Title - Sujet Construction of New SAR MOB	
Solicitation No. - N° de l'invitation EB144-191545/A	Amendment No. - N° modif. 003
Client Reference No. - N° de référence du client EB144-19-1545	Date 2018-10-25
GETS Reference No. - N° de référence de SEAG PW-\$PWA-121-5794	
File No. - N° de dossier PWA-8-80050 (121)	CCC No./N° CCC - FMS No./N° VME
Solicitation Closes - L'invitation prend fin at - à 02:00 PM on - le 2018-10-30	Time Zone Fuseau horaire Atlantic Daylight Saving Time ADT
F.O.B. - F.A.B. Plant-Usine: <input type="checkbox"/> Destination: <input checked="" type="checkbox"/> Other-Autre: <input type="checkbox"/>	
Address Enquiries to: - Adresser toutes questions à: Russell (PWA), Alex	Buyer Id - Id de l'acheteur pwa121
Telephone No. - N° de téléphone (902) 401-8180 ()	FAX No. - N° de FAX (902) 496-5016
Destination - of Goods, Services, and Construction: Destination - des biens, services et construction:

Addendum No.2

Job Title: BIO SEARCH & RESCUE MARINA OPERATIONS BUILDING

Addendum No.3

1
ESK-3

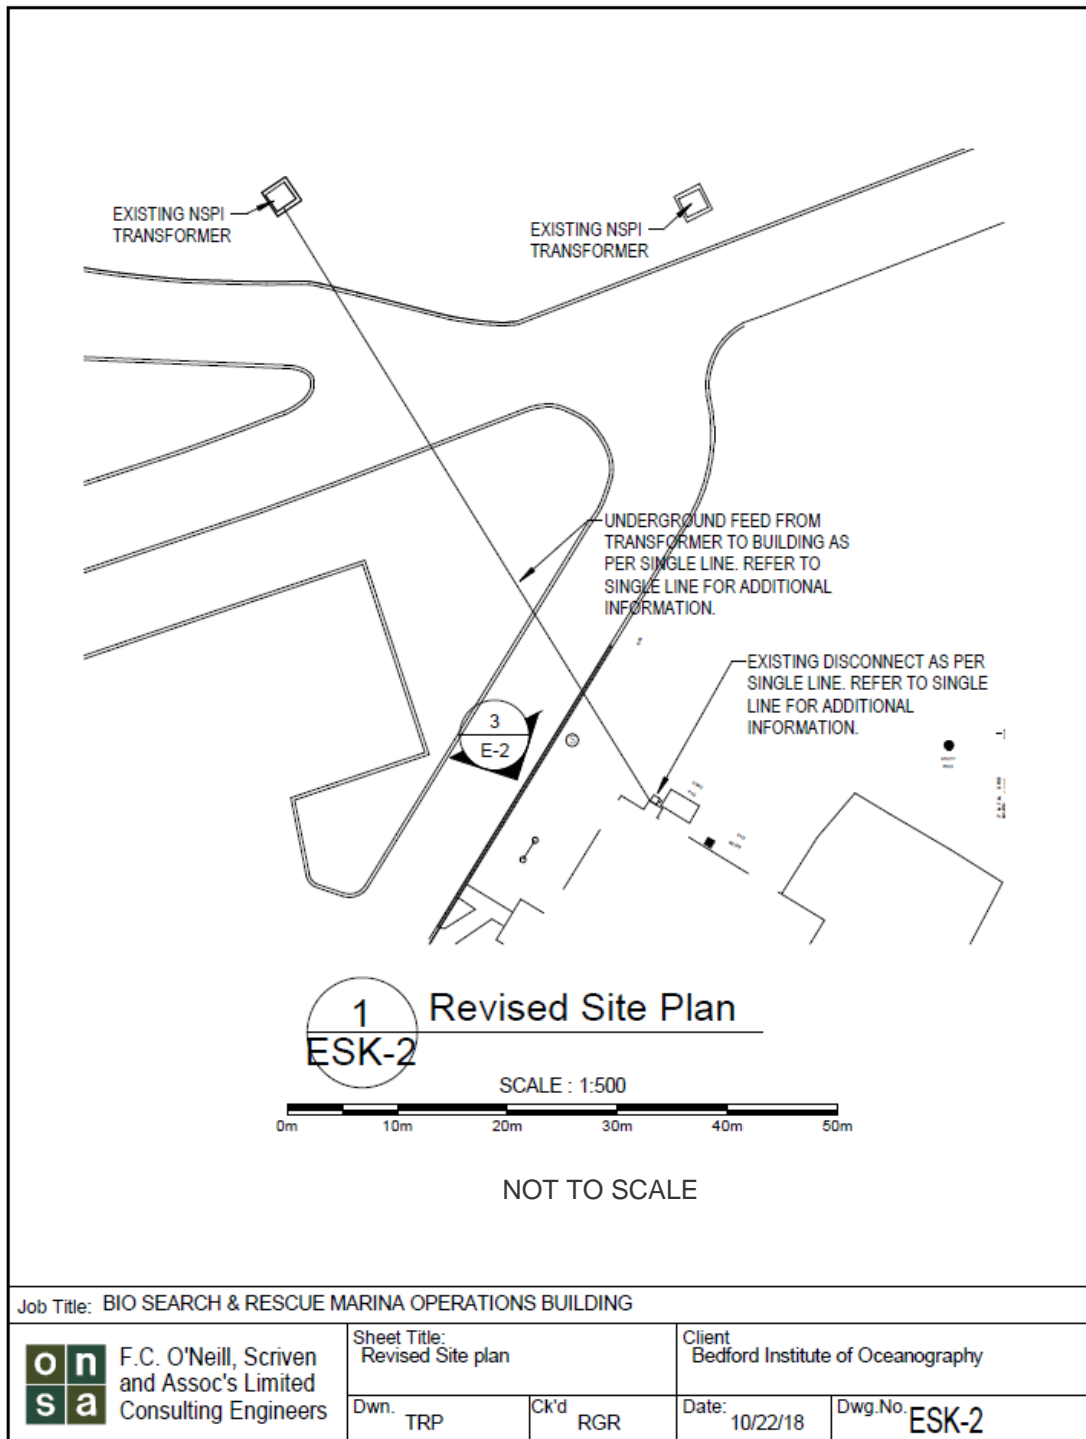
1. Underground feed from Argo building to existing NSPI transformer to be revised as noted in ESK-2 Revised Site Plan.
2. New fire alarm feed from Search and Rescue building to Holland building main fire alarm panel to be installed as indicated in ESK-3 Fire Alarm Feed.

2. Reference Drawing E-4 – Power & Communications Plans

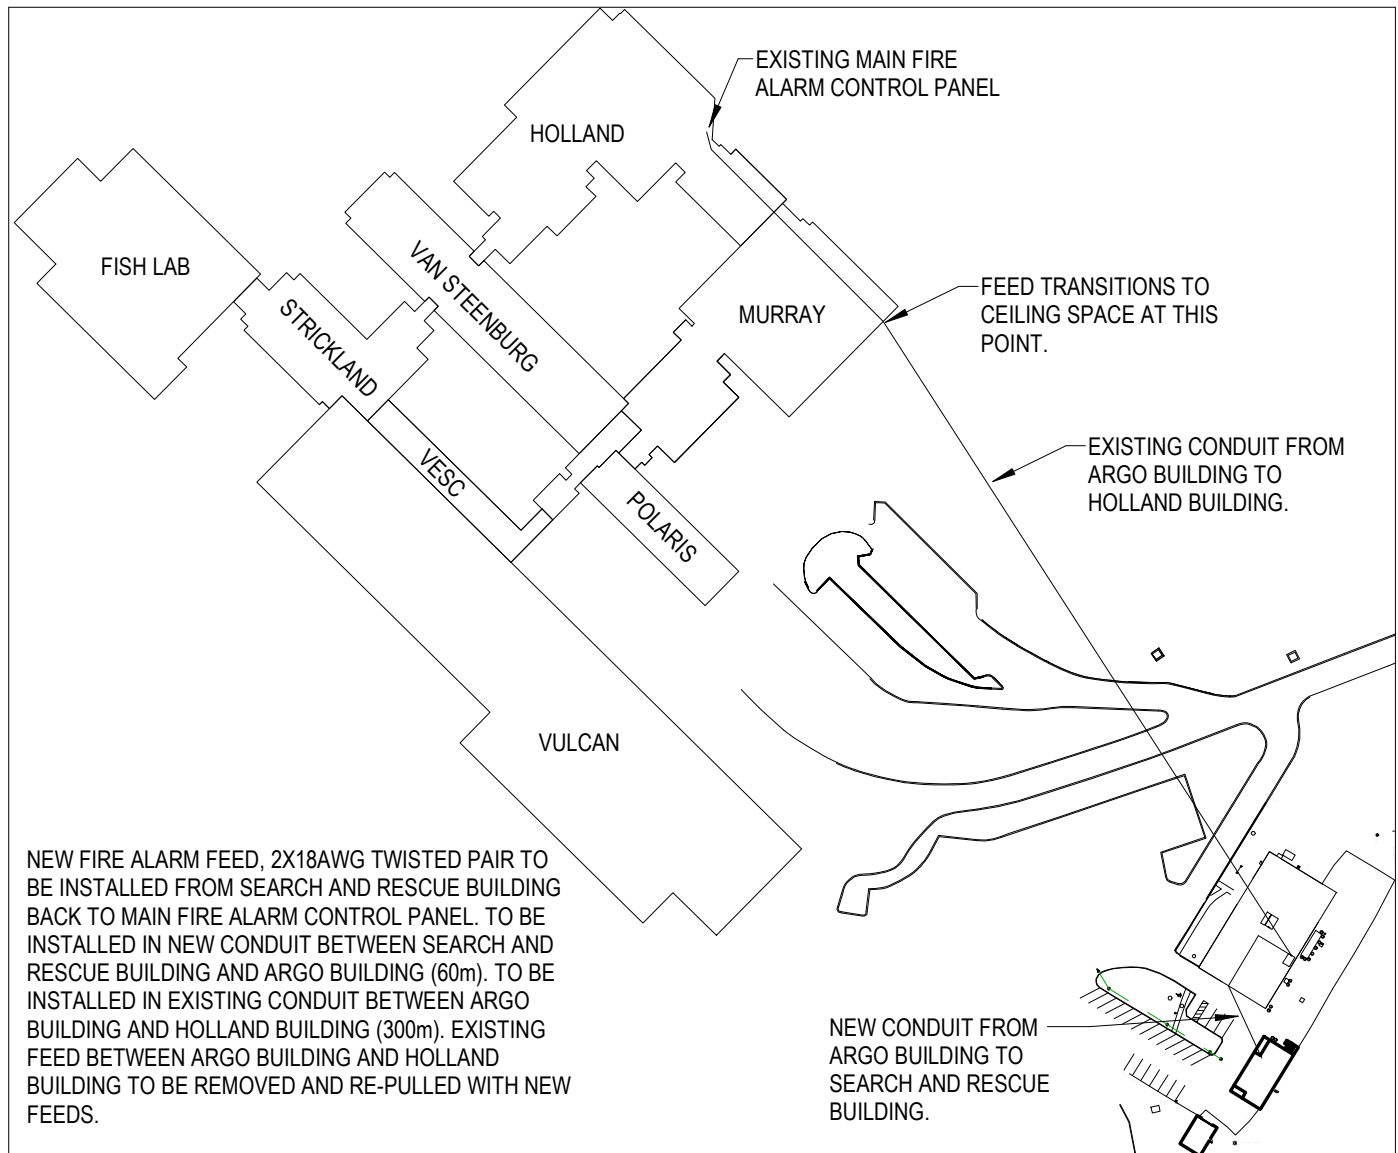
1. Data jacks to be revised in rooms 107 and 107 as noted in attached ESK-4 Additional Power & Data.
2. Dual duplex outlet circuited from 101-31 to be added to east wall of room 106 as noted in attached ESK-4 Additional Power & Data.
3. 22mm conduit to be installed from office 107 to roof as noted in attached ESK-4 Additional Power & Data.
